APPLICATION NO.	FILING DATE	FIRST NAMED INVENTOR	ATTORNEY DOCKET NO.	CONFIRMATION NO.
09/787,398	03/16/2001	Werner Kruger	P01,0019	2420
29177	7590	06/07/2005	EXAMINER	
BELL, BOYD & LLOYD, LLC P. O. BOX 1135 CHICAGO, IL 60690-1135			CHIANG, JACK	
			ART UNIT	PAPER NUMBER
			2642

Office Action Summary	Application No. 09/787,398	Applicant(s) KRUGER, WERNER	
	Examiner Jack Chiang	Art Unit 2642

Title: BUS SYSTEM FOR TRANSMITTING OPTICAL
SIGNALS

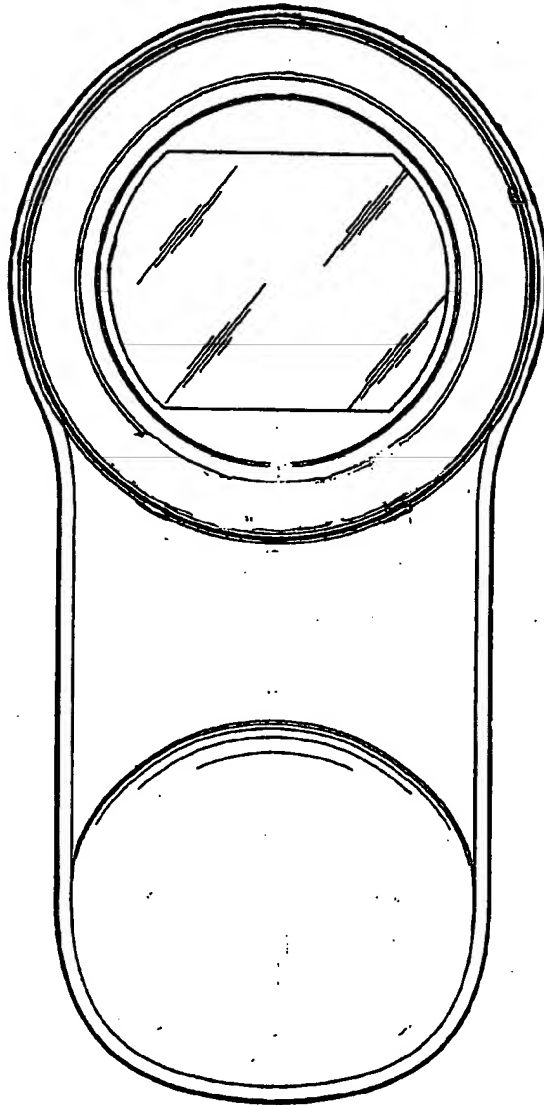
NOTE: proposed drawings filed on 12-29-04 are disapproved because the original disclosure does not support the specific proposed rotation, the specific locations of the various components etc. Therefore, it may contain new matter, and is disapproved.

*Not
Approved*
5/29/05

NOT
Approved
J
5/23/05
